TRANS/WP.29/GRE/2005/19
18 February 2005

**PROPOSAL FOR DRAFT AMENDMENTS TO REGULATION No. 98
(Headlamps with gas-discharge light sources)**

Transmitted by the expert from the Working Party "Brussels 1952" (GTB)

"Figure D (Class E headlamp for right hand traffic)

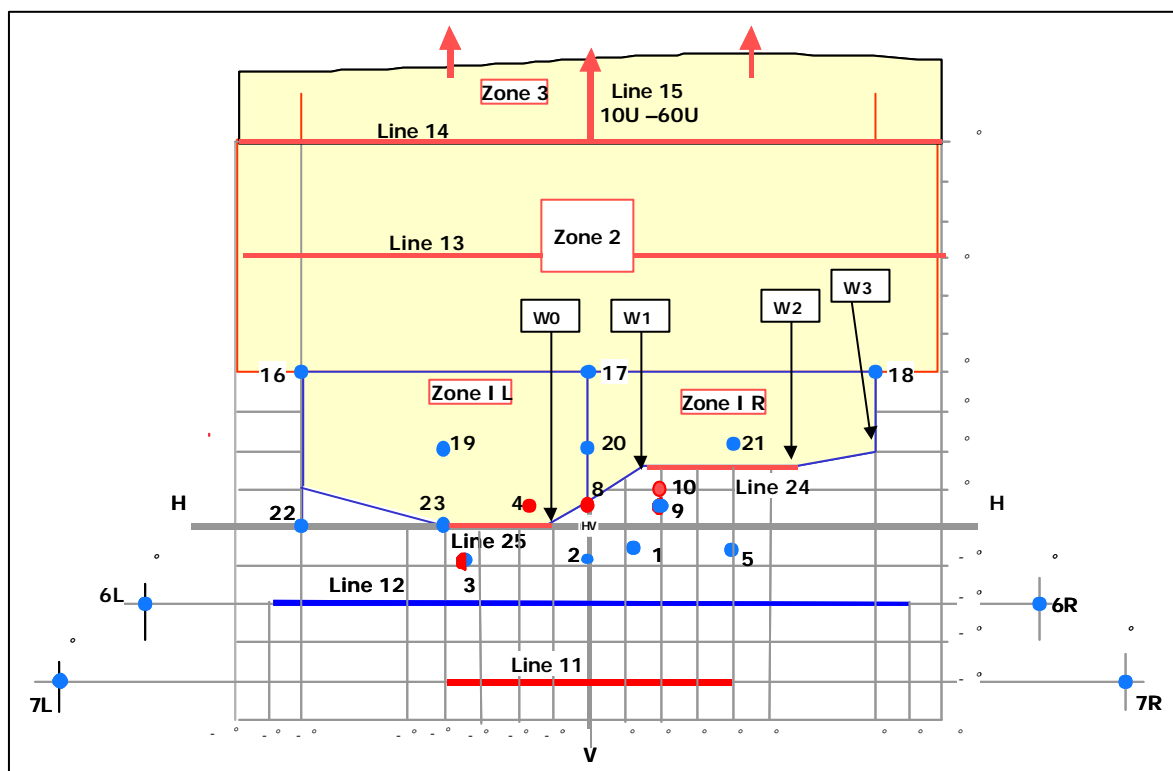
Add at the end of Annex 3, figures D, E, F and G, to read:

Figure F - Primary driving beam

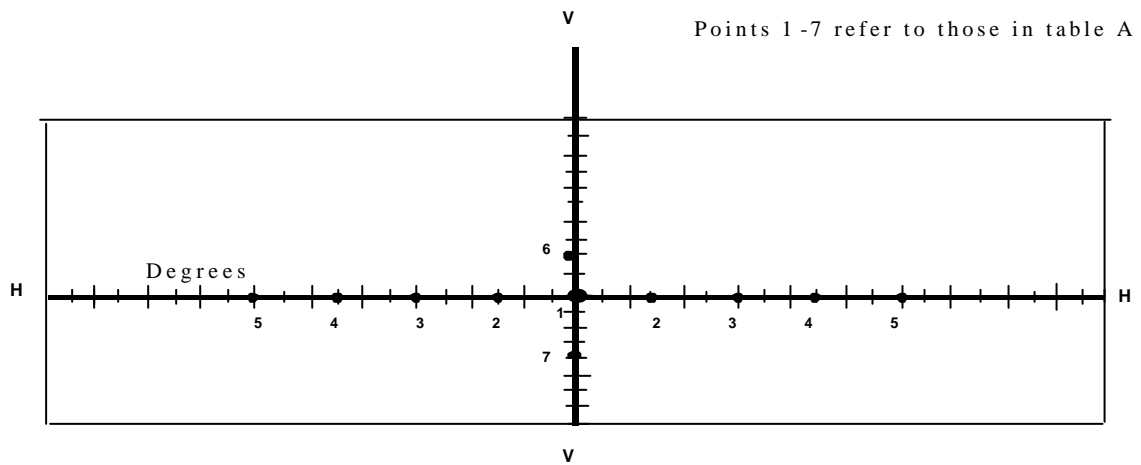
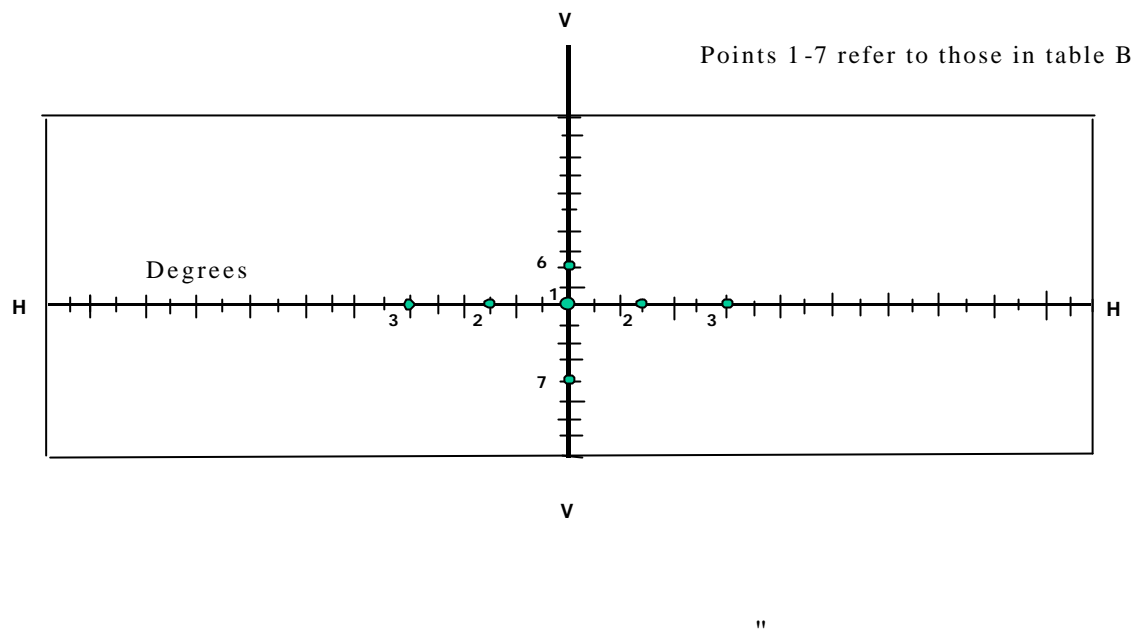
Refer to Figure F for details of test point positions

Figure 1

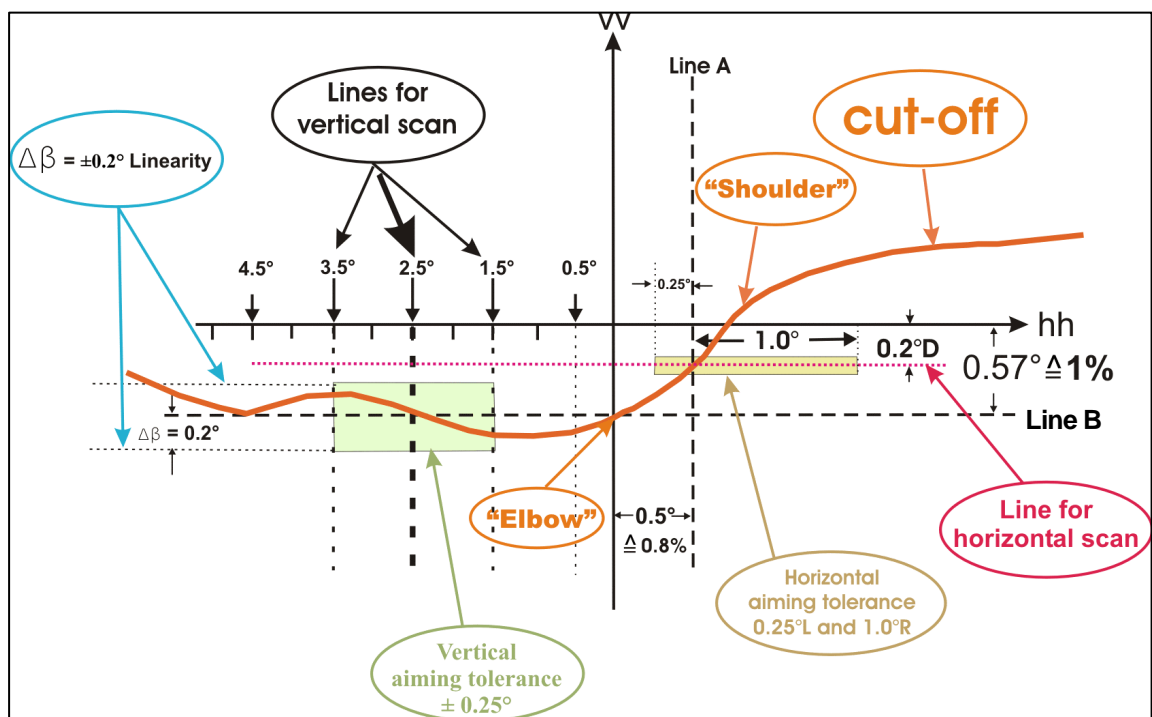
The "cut-off" line shall provide a straight horizontal line between 1.5° and 3.5° to the left of the v-v-line (see Figure 1)(to the right)

Figure 2: Instrumental vertical and horizontally adjustment - horizontal line scan method

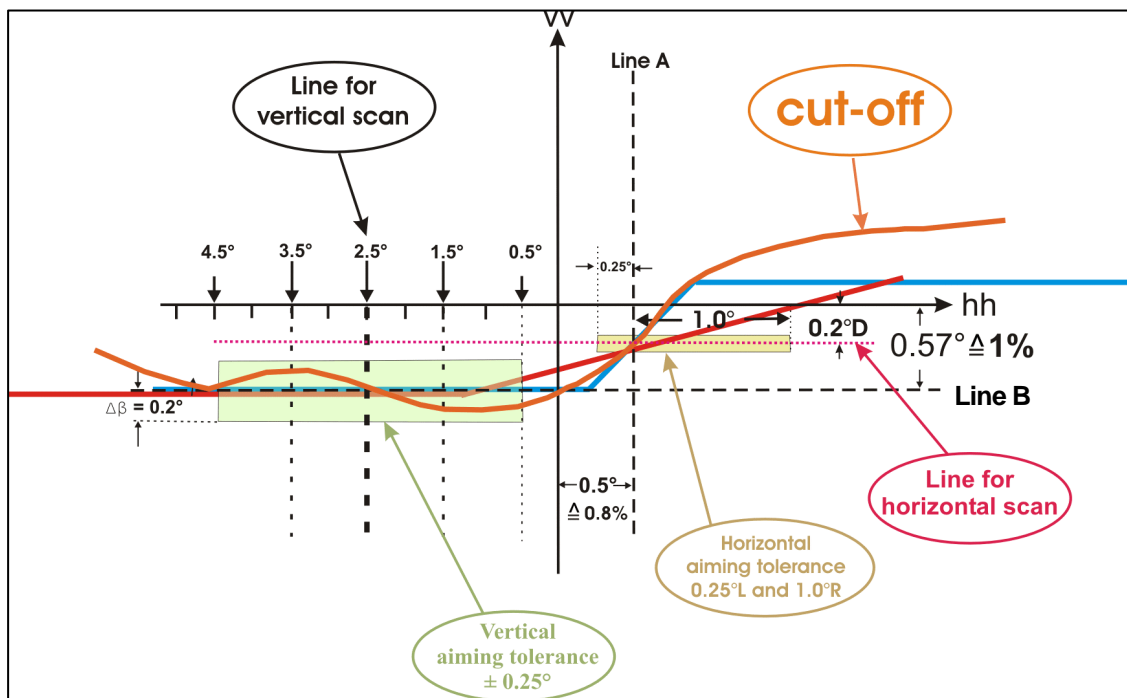
If the "0.2D line" method (Figure 2) is used, a single horizontal line shall be scanned. The minimum gradient found on the 0.2D line shall be not less than 0.08.

If the "0.2D line" method (Figure 2) is used, a single horizontal line at 0.2° D shall be scanned from 5L to 5R after the lamp is aimed vertically. Determine the maximum gradient as defined in paragraph 4.2. above, shall not be less than 0.08. The maximum gradient positions found on the 0.2D line shall be placed on the V line."

Figure 3: Instrumental vertical and horizontal adjustment - three line scan method

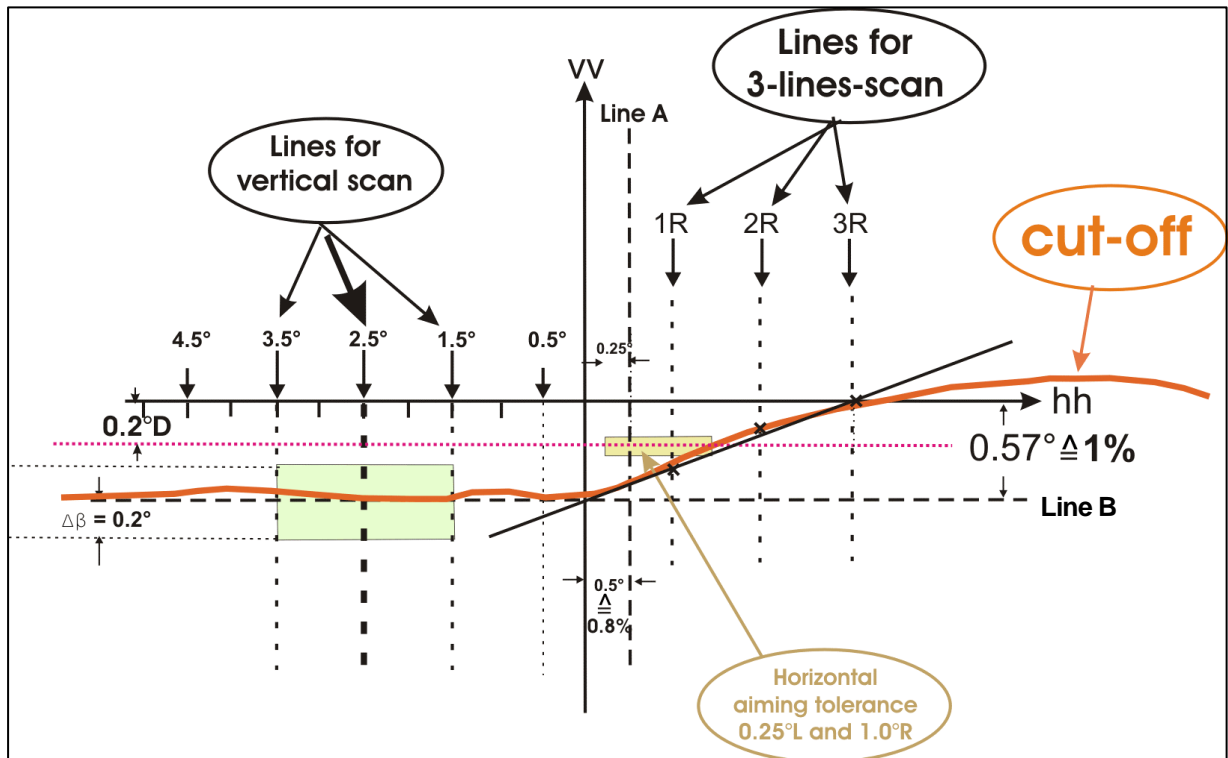
If the "3 line" method (Figure 3) is used, 3 vertical lines shall be scanned at 1R, 2R, and 3R after the lamp is aimed vertically.

If the "3 line" method (Figure 3) is used, 3 vertical lines shall be scanned at 2°D to 2°U at 1R, 2R, and 3R after the lamp is aimed vertically. Determine the maximum

gradient as defined in paragraph 4.2. above, shall not be less than 0.08 and "A" is vertical angular position. The maximum gradient positions found on the 3 lines shall be used to construct an angled straight line. The intersection of this line and the 0.57D position found while performing vertical aim shall be placed on the V line.
